SECTION 4.55(1A) MODIFICATION REPORT - ATLASSIAN CENTRAL DEVELOPMENT

Section 4.55(1A) Application to
modify SSD-10405 | 8-10 Lee Street,
Haymarket

Prepared for
VERTICAL FIRST
3 October 2025

Figure 1 Proposed Crown Event Space Amendments on Level 35 and 36

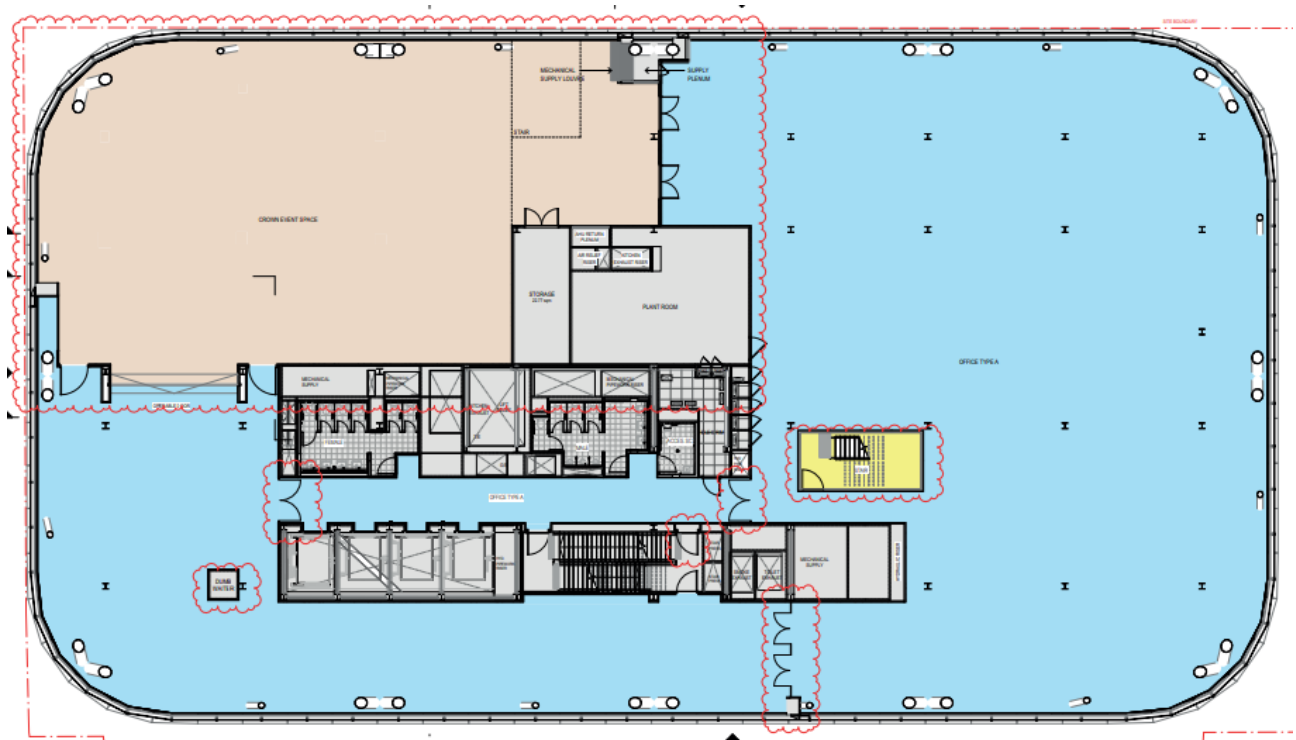
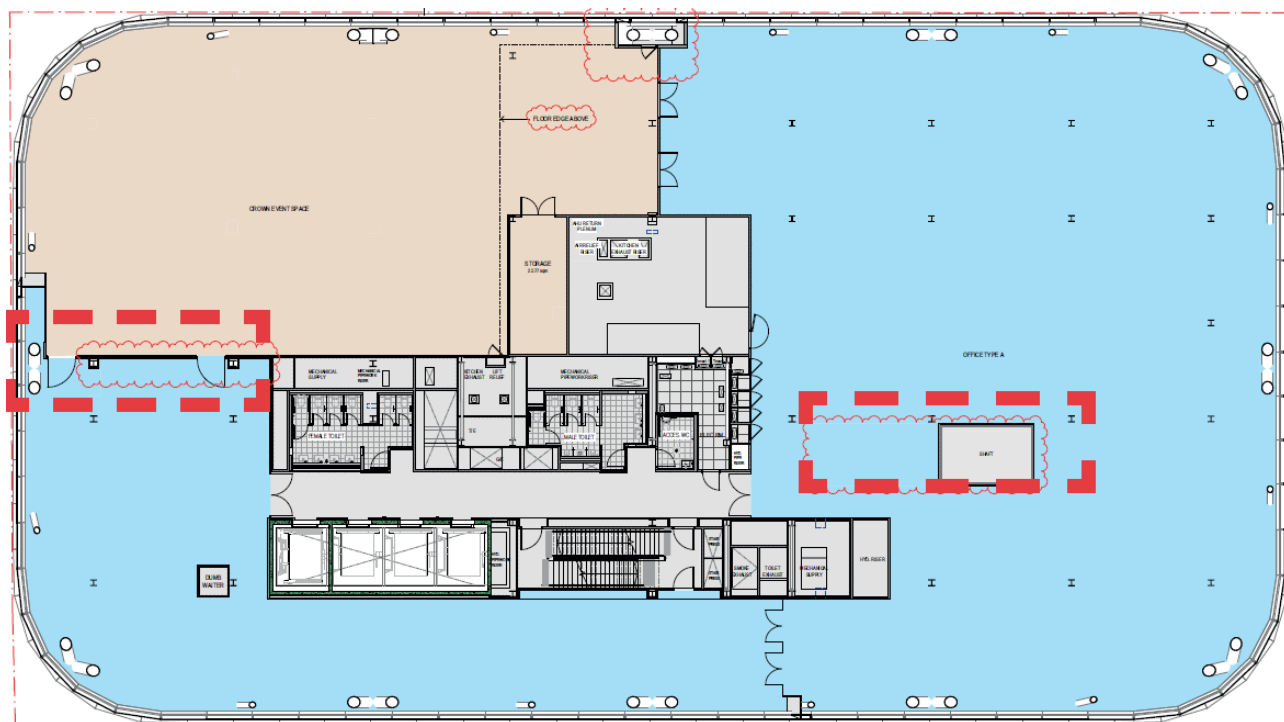
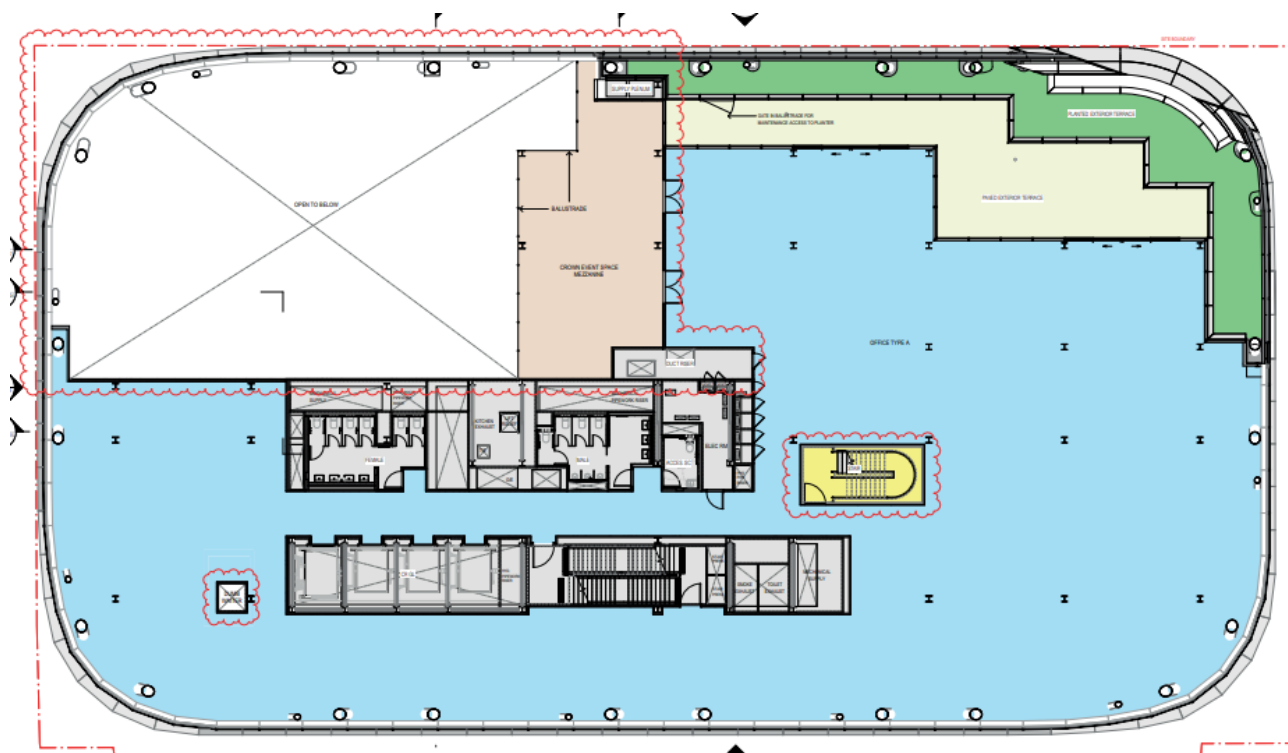
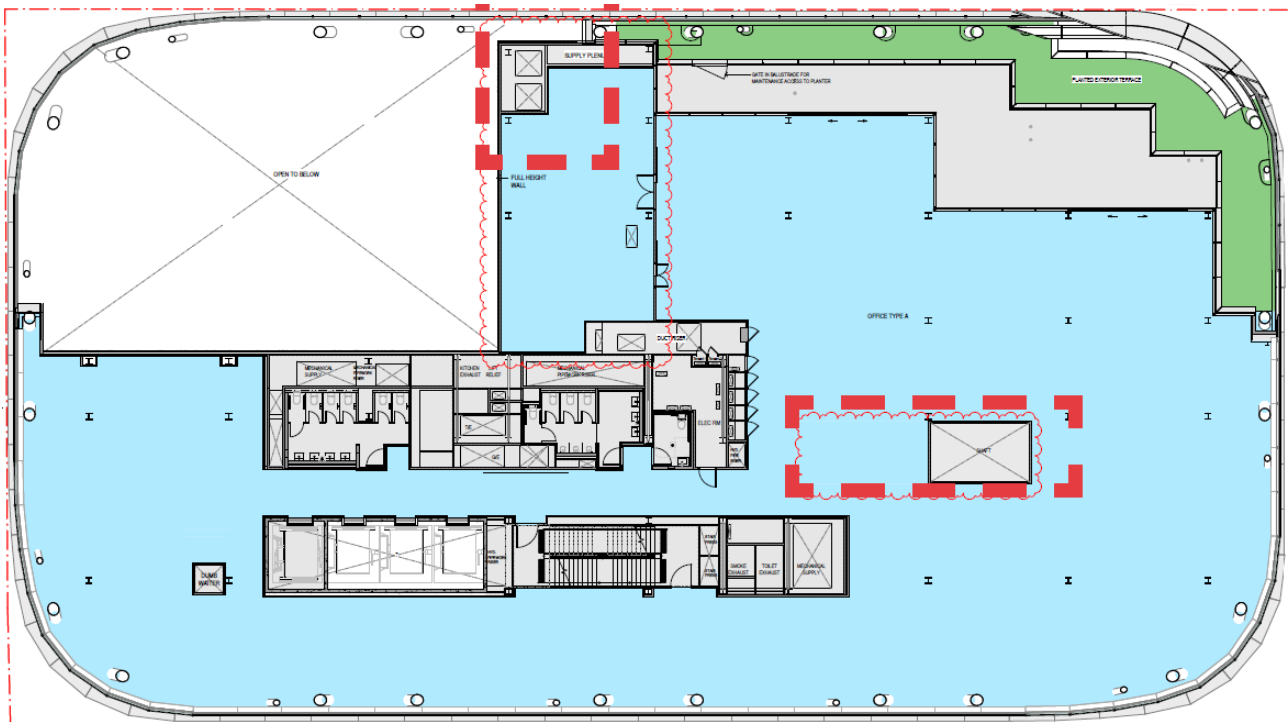
- Replacement of skyfold door with full height wall. This is to allow the future flexibility for the entry to the event space and for compliance as a fire-rated wall.
- Replacement of crown event space mezzanine balustrade with full height wall to enable this space to function separately to the crown event space itself.
- Deletion of crown event space stair void at level 35-36 as a stair in this location is no longer required, and inclusion of air supply plenum at level 36 to allow for increased ceiling heights to level 35 below.

At levels 35 and 36 the office space stair is proposed to be removed, and the stair void moved one structural bay to the south. The structural bay will be fully enclosed. This is because an internal stair is no longer required in this location, and to future-proof a space for a stair should one be required in the future. **Figure 1** displays the proposed amendments at levels 35 and 36.

Figure 2 Approved and Proposed Level 37 and 38 Floor Plans

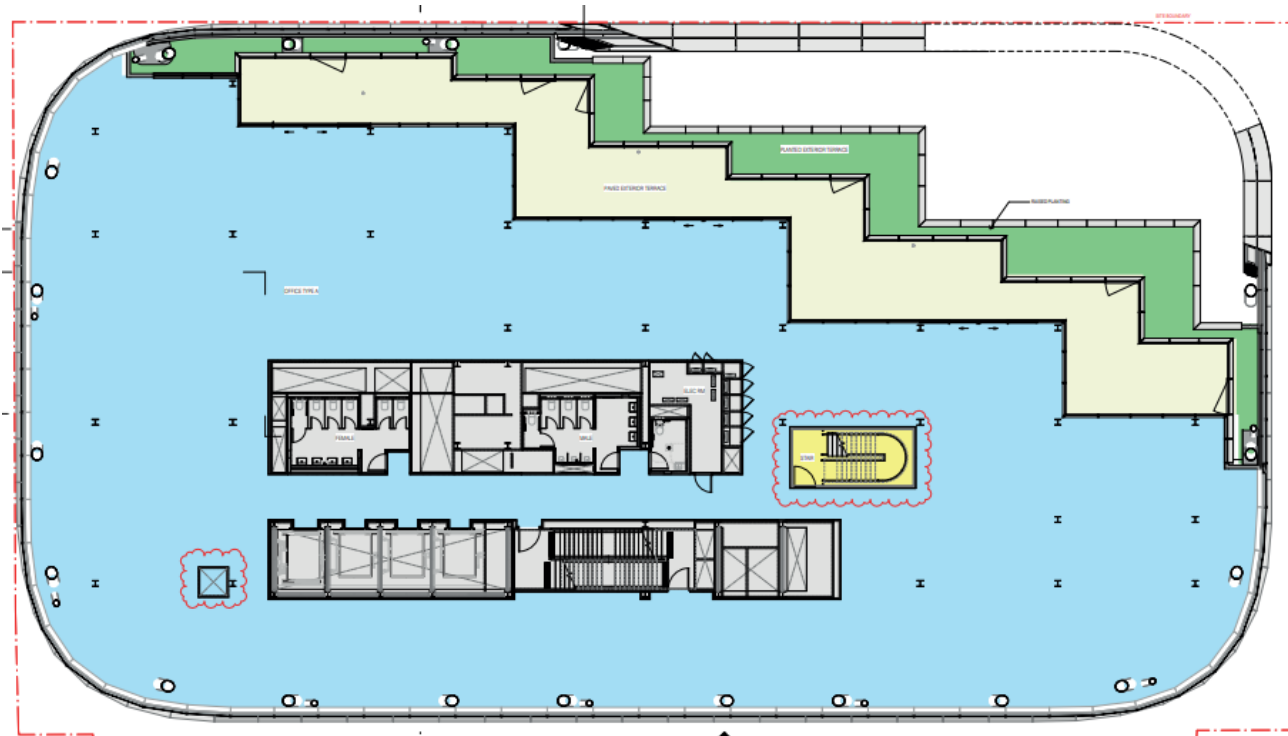
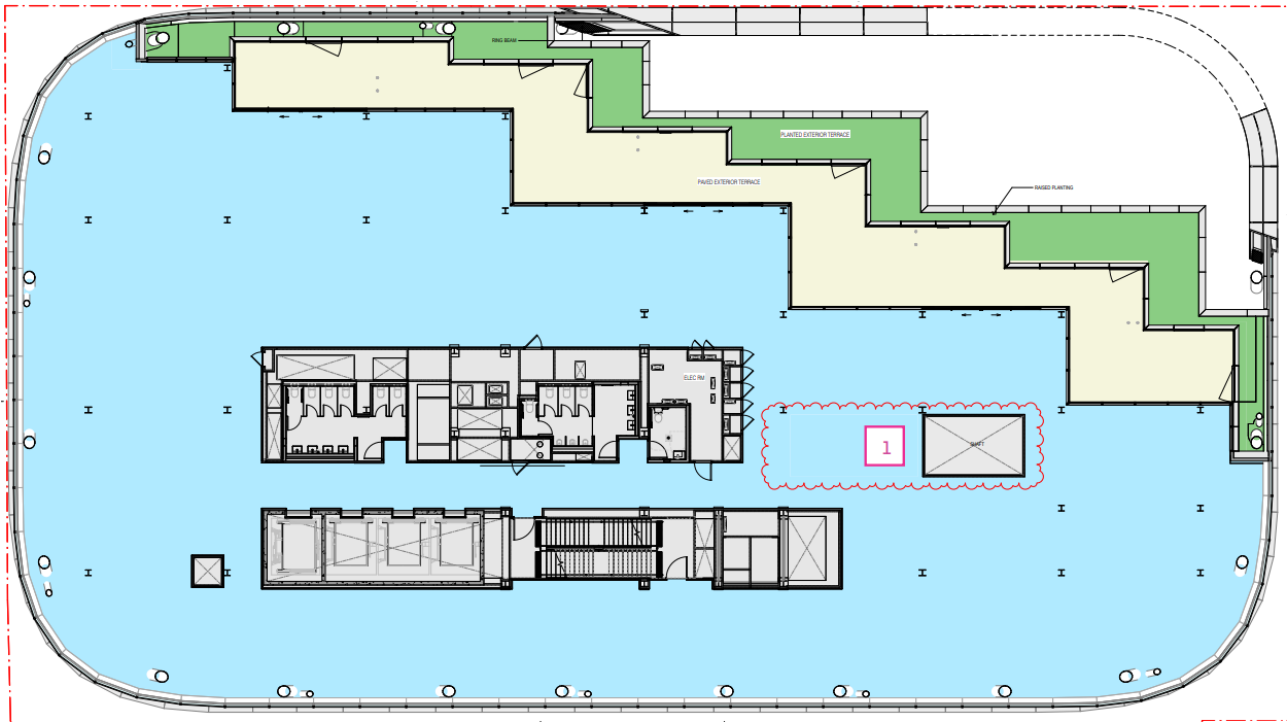
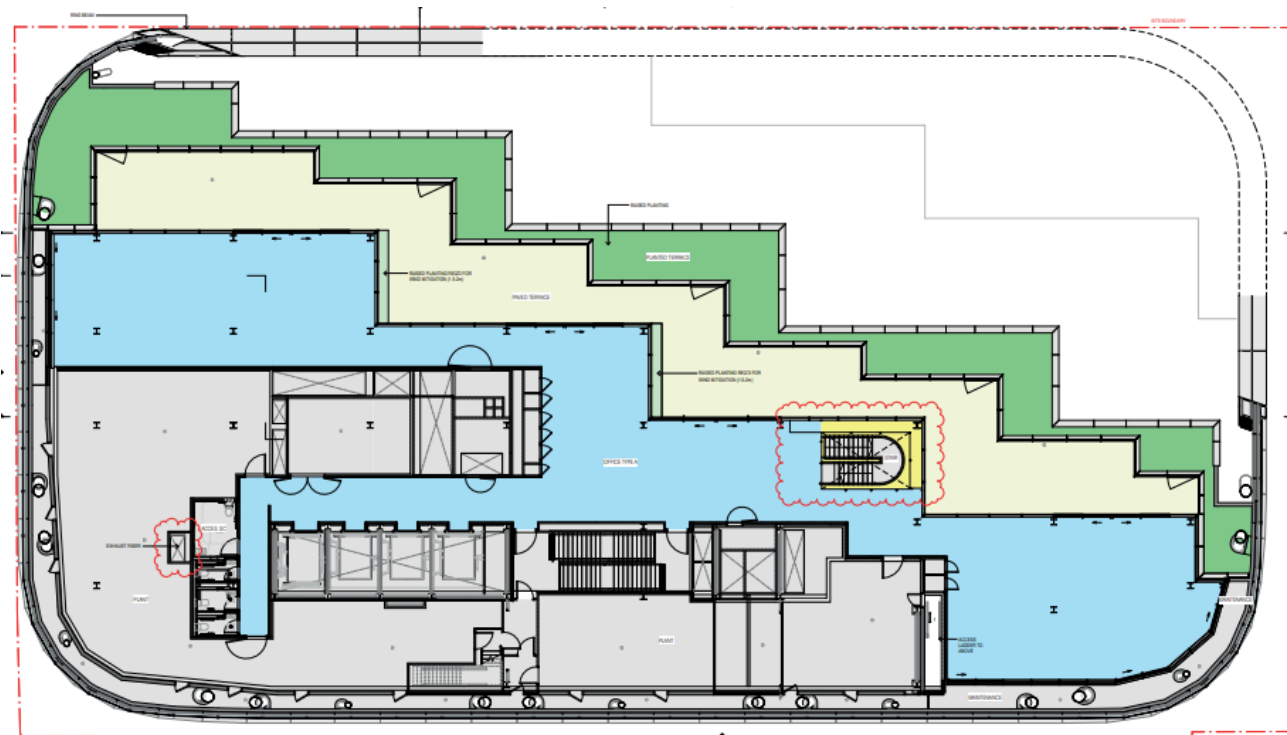
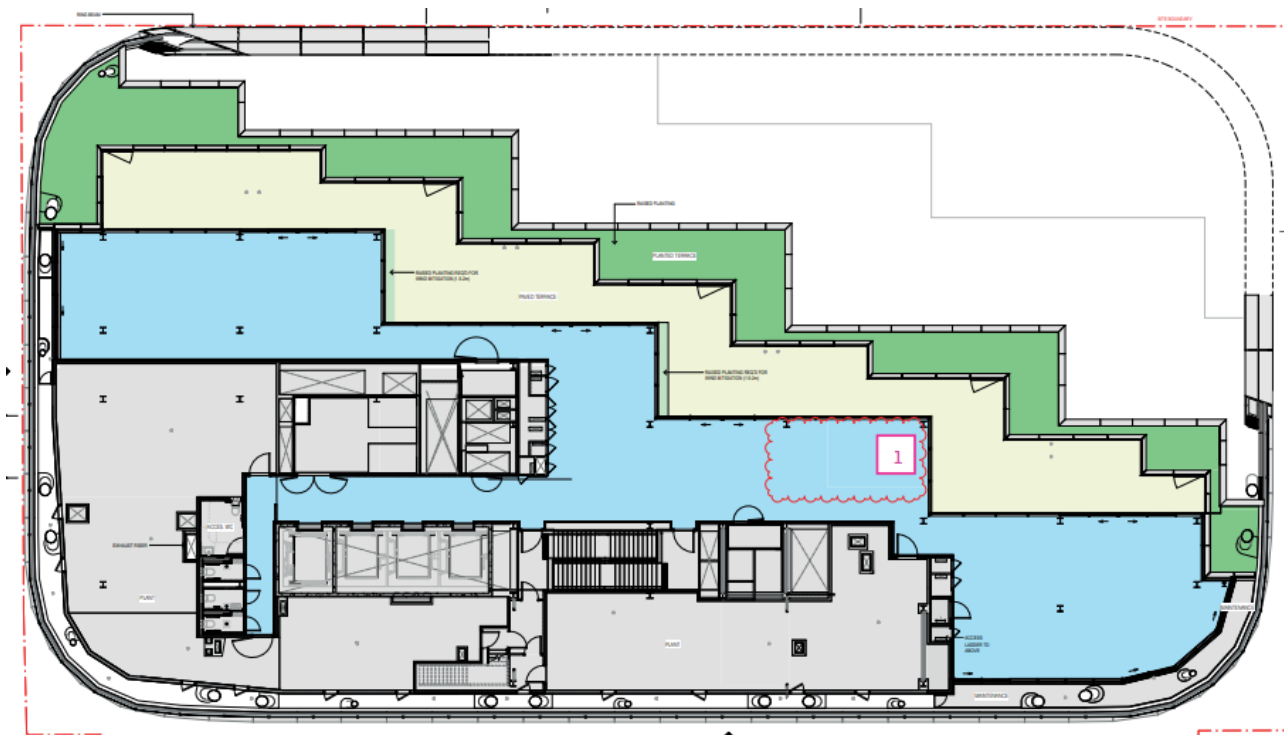
Similar to levels 35 and 36, it is proposed to remove the office space stair at levels 37 and 38. This is because an internal stair is no longer required in this location. At level 37, it is also proposed to move the stair void one structural bay to the south. The structural bay will be fully enclosed. This is to future-proof a space for a stair should one be required in the future.

Figure 3 Level 35 plant room – GFA change

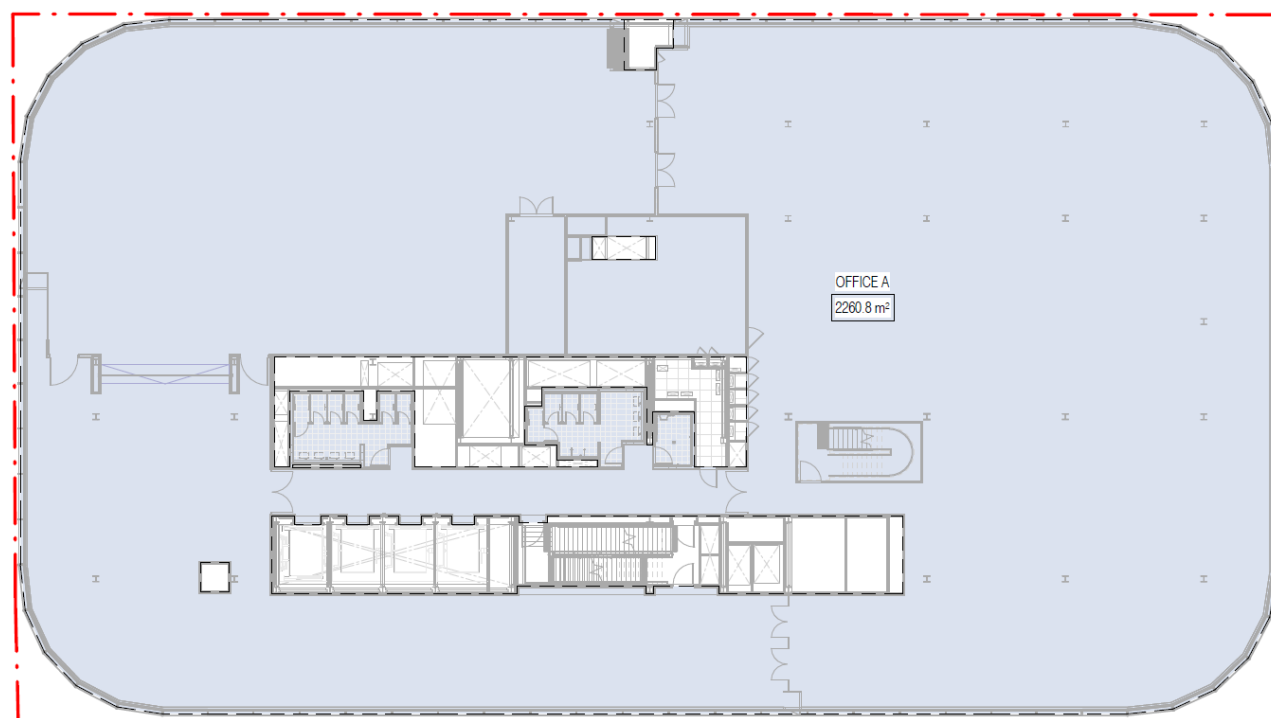
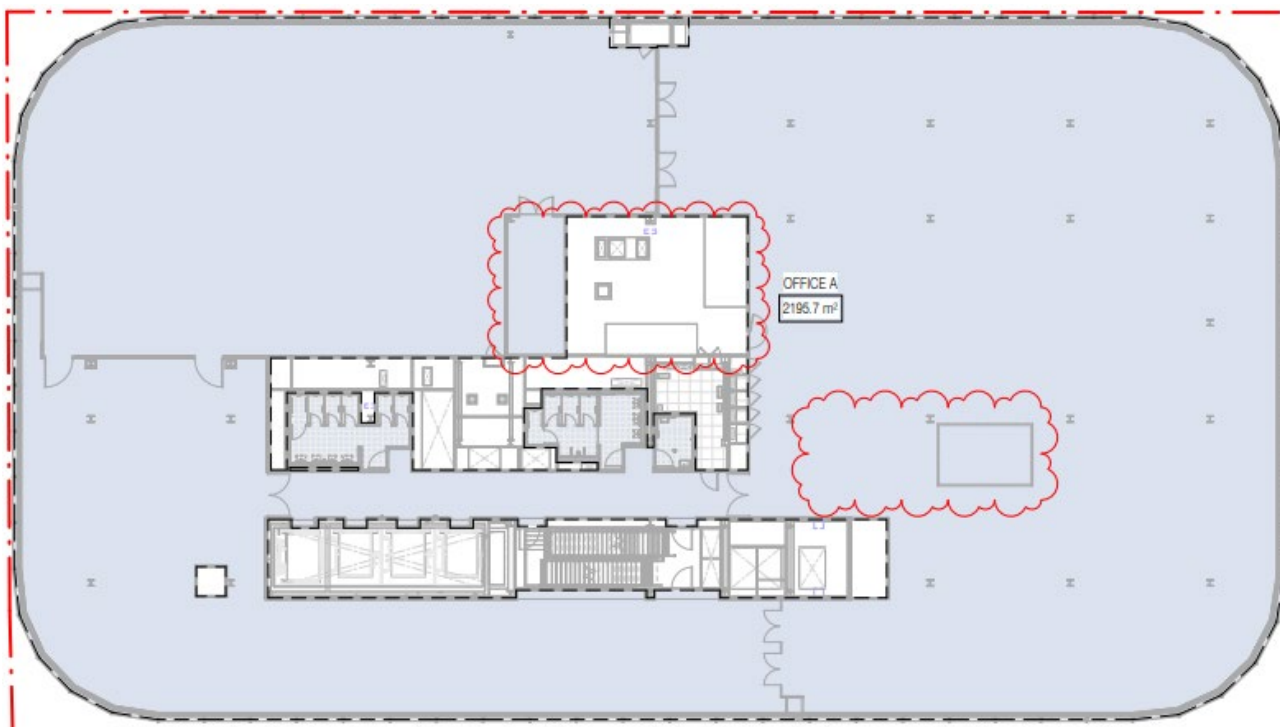
The proposed minor amendments described in the above sections results in minor changes to the approved GFA. Overall, a 72m² decrease in the approved GFA at the site is proposed as part of this Modification. This is primarily due to the level 35 plant room mistakenly being identified as GFA in Modification 9. This is proposed to be corrected in this Modification, with the plant room being removed from the GFA area.
